Re: Custom House Square, 300 Fore Street
Portland, ME
Structural Observations

Per your request, I visited the above referenced site Friday, May 18th, 2007, to perform a structural observation between the hours of 12:30 p.m. and 3:45 p.m. The temperature was approximately 45 degrees and it was raining. Larry Ross (superintendent) of Wright-Ryan Construction, Inc, allowed access to the site. The following is a brief summary of my findings:

SKS-09

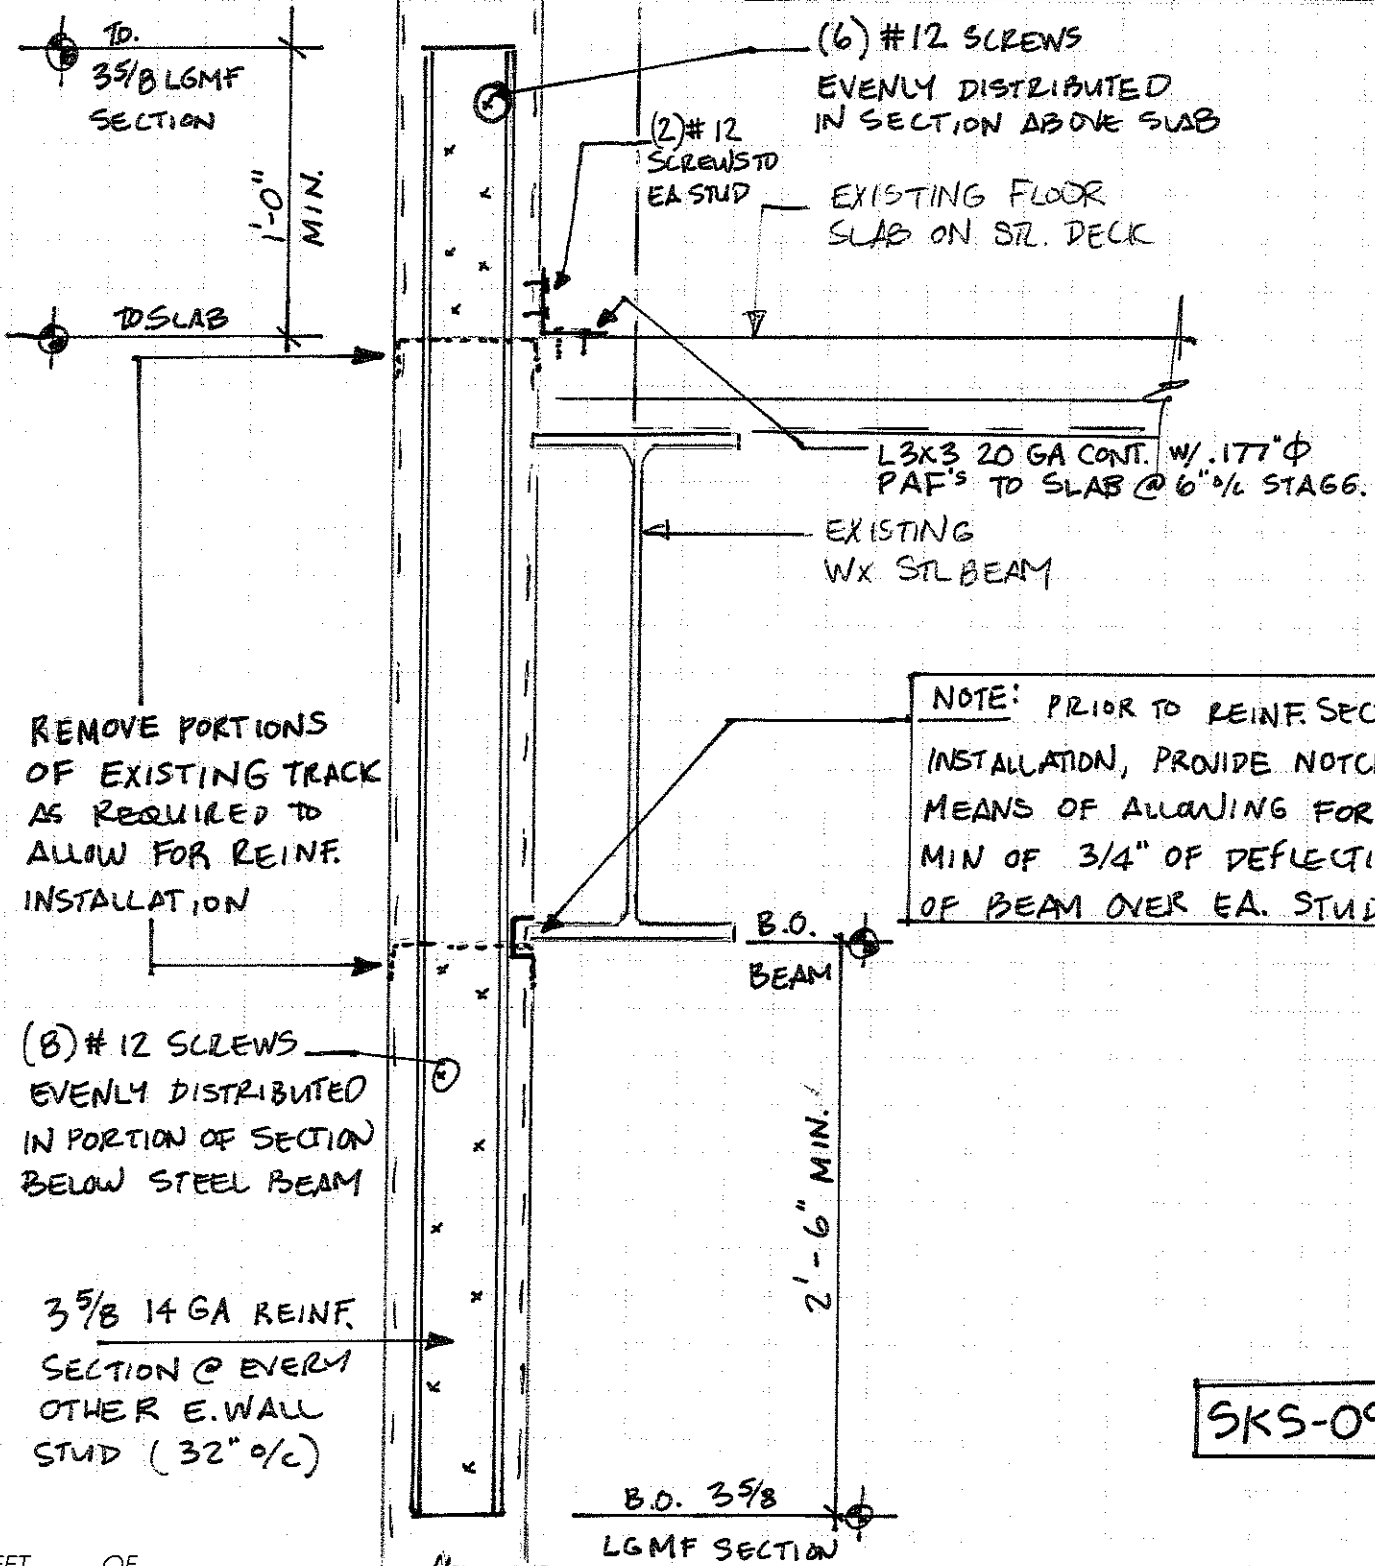
Along the "1" line of the structure, in bays at various levels, there were locations in which the 6" LGMF exterior wall did not bypass the floor framing as shown in the design. The LGMF at the exterior wall must resist out of plane wind loading (both pressure and suction). Said loading must be transferred directly to the floor diaphragm as indicated on the structural details. As viewed the LGMF terminated at the bottom flange of the steel beams, thus creating the potential for lateral loading (kicking in) at the bottom flange of the beam. Due to the exposed finish ceiling, it is not feasible to add wind bracing from the bottom flange of the beam to the floor diaphragm. Please refer to the attached sketch, SKS-09, which indicates the LGMF reinforcing required to transfer the support of the stud framing from the bottom flange of the beam to the design location near the top of the beam.

NOTE: APPLICATIONS OF THIS SECTION MUST APPLY AT EACH LEVEL ALONG "1" LINE WHERE LGMF WALL INTERRUPTED BY BEAM

NOTE: PRIOR TO REINF. SECTION INSTALLATION, PROVIDE NOTCH OR MEANS OF ALLOWING FOR A MIN OF 3/4" OF DEFLECTION OF BEAM OVER EA. STUD
